World Forum for Harmonization of Vehicle Regulations**Working Party on Noise and Tyres****Seventy-seventh session**

UN Regulation No. 51 (Noise of M and N categories of vehicles)**Proposal for corrections to the 03 series of amendments to
UN Regulation No. 51****Submitted by the experts from the Informal Working Group on
Measurement Uncertainties, the Informal Working Group on
Additional Sound Emission Provisions and from the International
Organization for Standardization***

"Figure 4a

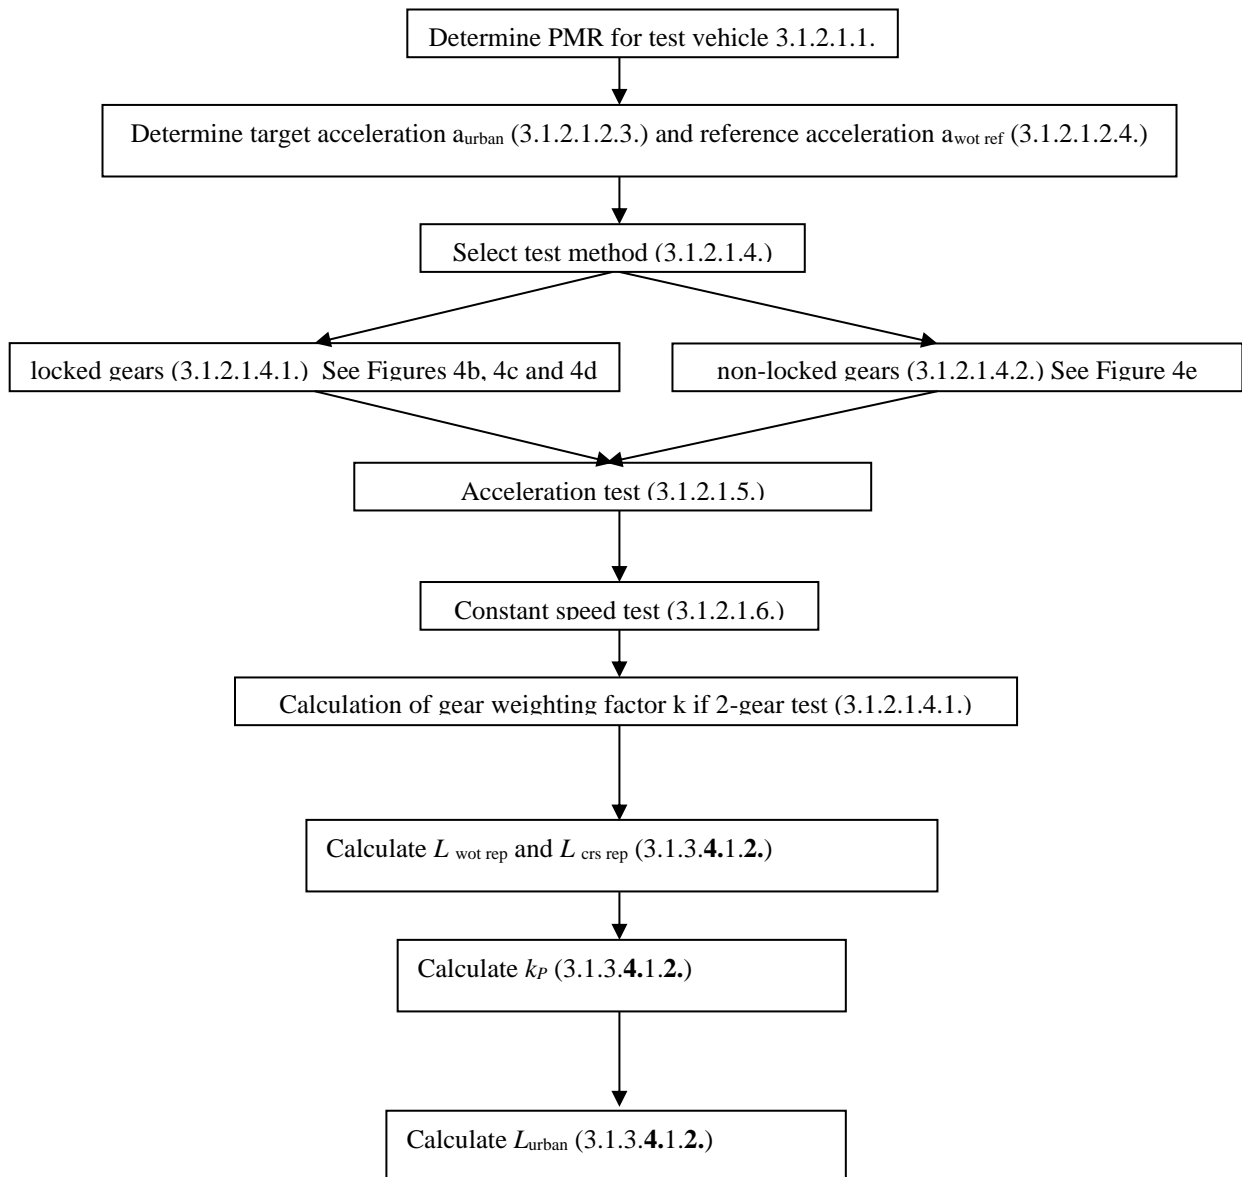
Figure 4a, amend to read:

3. The content of paragraph 3.1.3.1. was moved to paragraph 3.1.3.4.1.2. without any change when RD-ASEP was introduced in Supplement 7. In the figures, references to this paragraph 3.1.3.1. need to be renumbered to 3.1.3.4.1.2., accordingly.

"Figure 4b

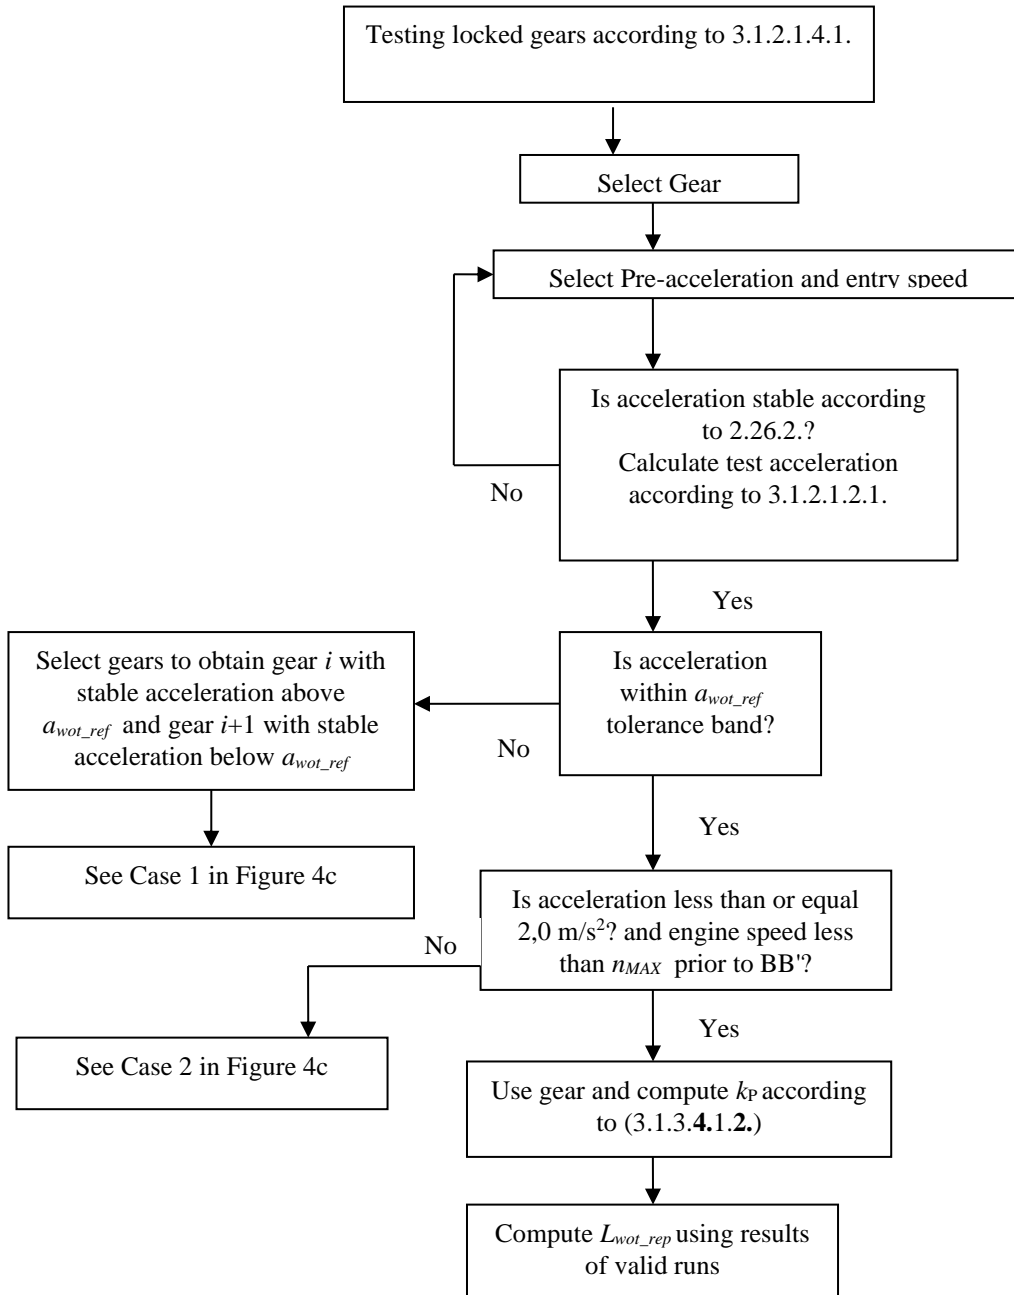
Figure 4b, amend to read:

"Figure 4c

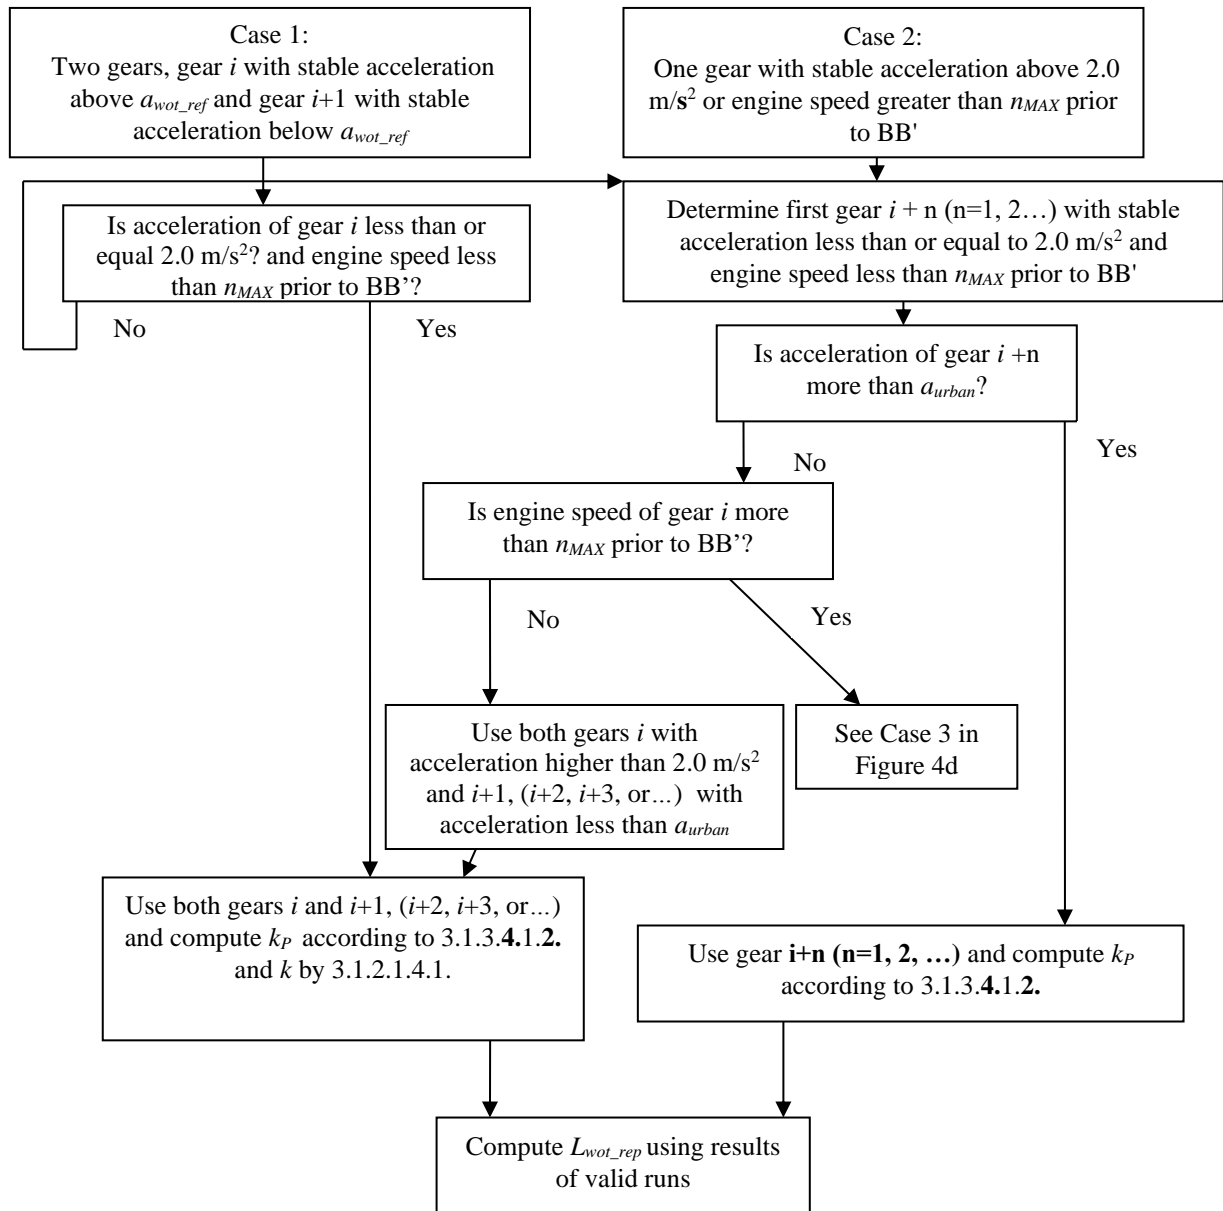
Figure 4c, amend to read:

4. In Figure 4c, from the current wording in Annex 3, paragraph 3.1.2.1.4.1.(c), the addition of "i+n (n=1, 2, ...)" in the box "Use gear and compute k_p according to 3.1.3.4.1.2." was made for better understanding and clarification.

"Figure 4d

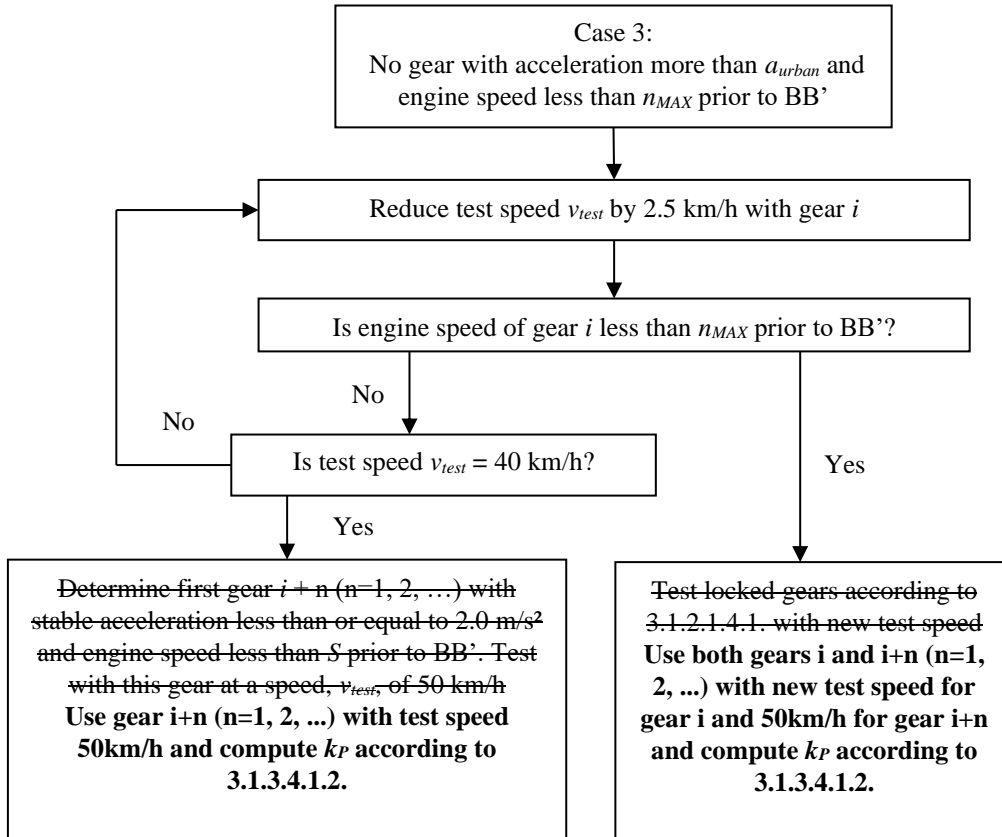
Figure 4d, amend to read:

5. In Figure 4d, to avoid misinterpretation, the following modifications were made from the current wording in Annex 3, paragraph 3.1.2.1.4.1.(d) for clarification and better understanding:

- Adding "=" in the box "Is test speed v_{test} 40km/h".
- Replacing "Determine first gear $i + n$ ($n=1, 2, \dots$) with stable acceleration less than or equal to 2.0 m/s^2 and engine speed less than S prior to BB' . Test with this gear at a speed, v_{test} , of 50 km/h" by "Use gear $i+n$ ($n=1, 2, \dots$) with test speed 50km/h and compute k_p according to 3.1.3.4.1.2".
- Replacing "Test locked gears according to 3.1.2.1.4.1. with new test speed" by "Use both gears i and $i+n$ ($n=1, 2, \dots$) with new test speed for gear i and 50km/h for gear $i+n$ and compute k_p according to 3.1.3.4.1.2."

"Figure 4e

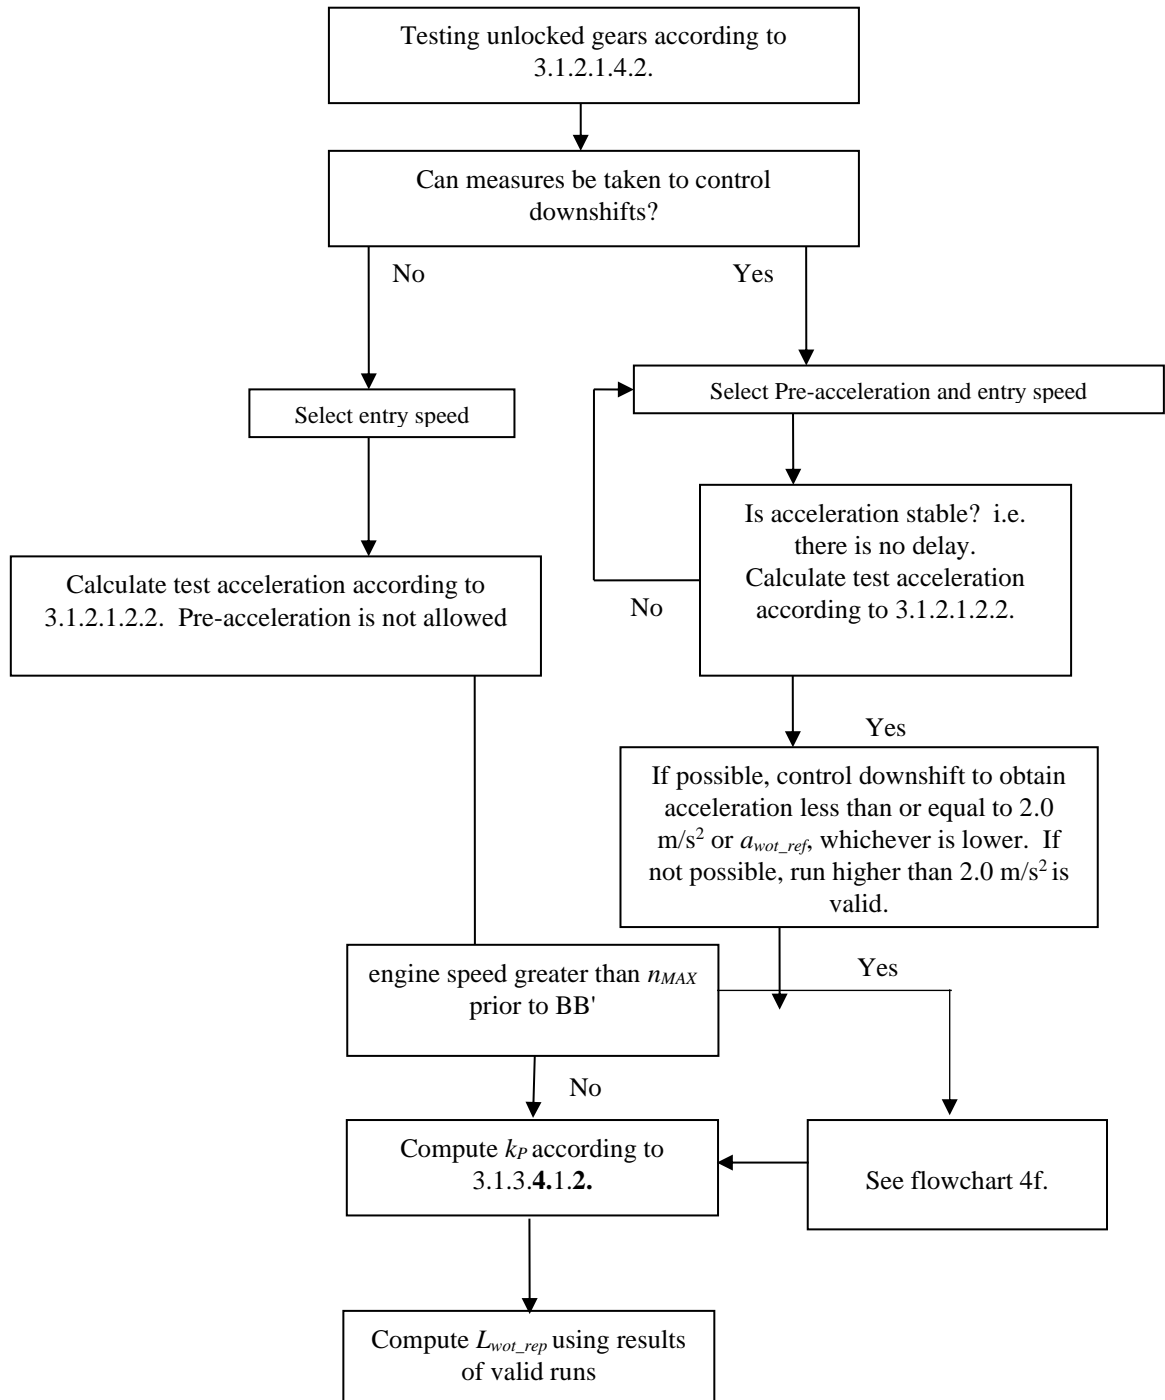
Figure 4e, amend to read:

“Figure 4f

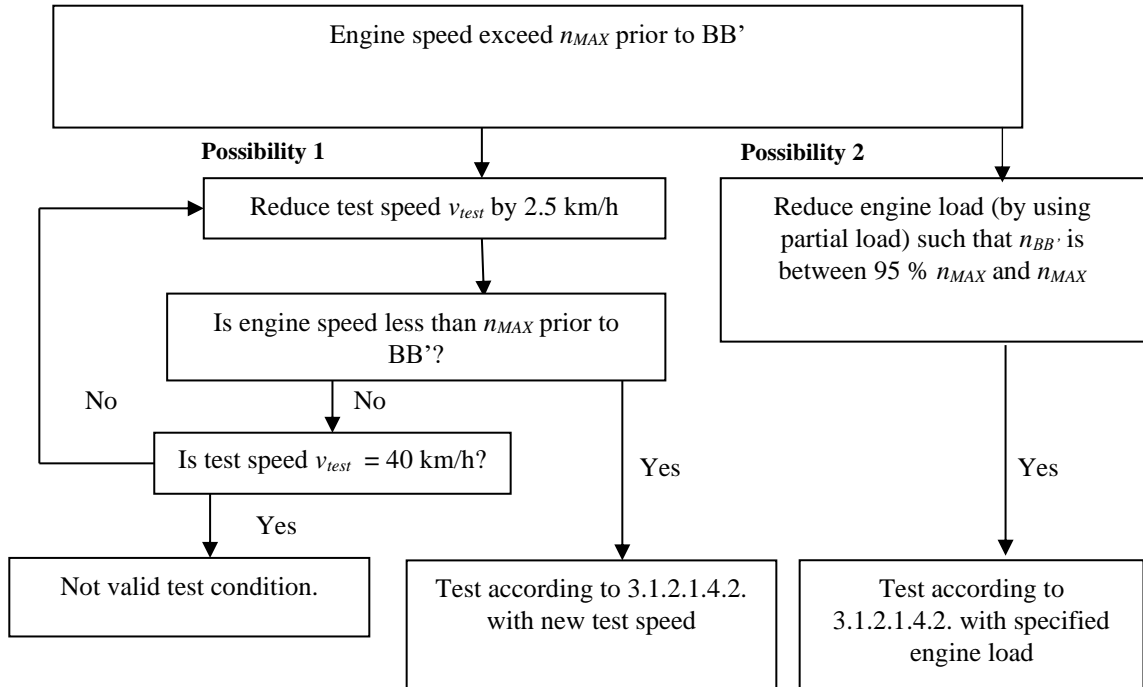
Figure 4f, amend to read:

6. In Figure 4f, from the current wording in Annex 3, paragraph 3.1.2.1.4.2., the addition of “=” in the box “Is test speed v_{test} 40km/h” was made for better understanding and clarification.
